Response to RC-1 review of the manuscript:

*“Characterizing groundwater heat-transport in a complex lowland aquifer using paleo-temperature reconstruction, satellite data, temperature-depth profiles, and numerical models”*

Manuscript ID: hess-2021-586.

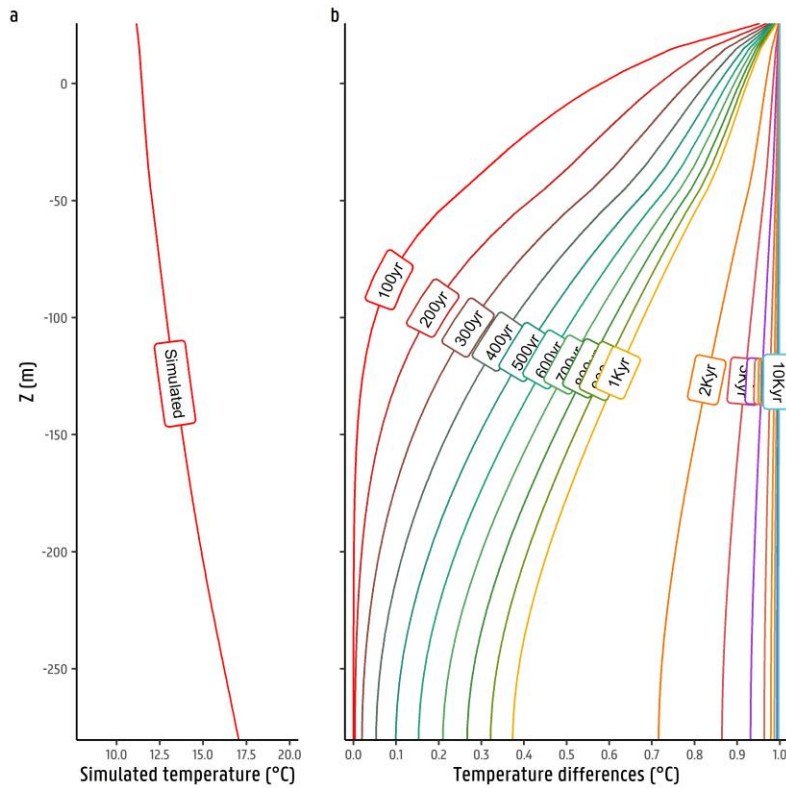
2. I am furthermore not clear of the benefit of running the model based on temperature time series starting in 8500 BC – we do not have accurate data for this far back and more importantly, the model reaches down only 400 m at most, at this depth surface temperatures from maybe a couple hundred years ago are dominating the thermal regime. Hence, I must recommend focusing rather on high-frequency and more accurate data that’s a bit more recent than on long time-series such as paleo-temperatures (e.g., climate reanalysis data such as ERA 5 or MERRA-2 or GISS Model E2).

**Commented [BK1]:** I would reverse this list, start with 10000, because this is also the sense/direction of the simulation

**Commented [BK2]:** Try to be consistent in time period designation

**Commented [BK3]:** This sentence reads a bit weird, try to rephrase

To demonstrate the importance of performing the paleo-temperature simulations to provide initial conditions for each stress period, a test was performed. Simulations were performed where the initial top boundary condition was disturbed by increasing 1 degree at various time steps (years before present i.e. 10000yr, 9000yr, 8000yr, 7000yr, 6000yr, 5000yr, 4000yr, 3000yr, 2000yr, 1000yr, 900yr, 800yr, 700yr, 600yr, 500yr, 400yr, 300yr, 200yr, 100yr) and for the remaining time-steps of the simulation period. The simulated temperature-depth (TD) profile from all these models was obtained for the same location (on well R-54f). The results of this test are shown in Figure 1. In Figure 1a, the simulated TD profile at the last time step (present time) from a normal (undisturbed) forward model run is shown. In Figure 1b, the differences between the disturbed and normal (undisturbed) simulated TD profiles are shown, pointing out the time required for the model to reach a steady-state given a change of 1 degree in the top boundary temperature condition. This shows that a couple of hundreds of years are still not sufficient to achieve a steady-state condition. For the purposes of our study, it is important to be able to reach this stability at these depths of the aquifer.

This supports the use of a relatively long time series which is actually a process that is not computationally intensive. The model in total has 337 stress periods (accounting the paleo-temperature time series for 111 steps, and 226 for the LST stress periods) and runs in around 40 minutes. For the 9 time steps in the stress period between 10000yr and 2000yr before present (in steps of 1000 years) it requires around a minute (approximately 64 seconds) to compute, offering the considerable temperature gain is of up to 30% per temperature degree of change at the temperature top boundary condition. Having a higher frequency temperature distribution is not within the scope of this work, as we are more interested in knowing what improvement the implementation of an additional state variable may bring to the conceptualization of the groundwater system rather than aiming for higher frequency results, for which monthly time-steps seem reasonable.
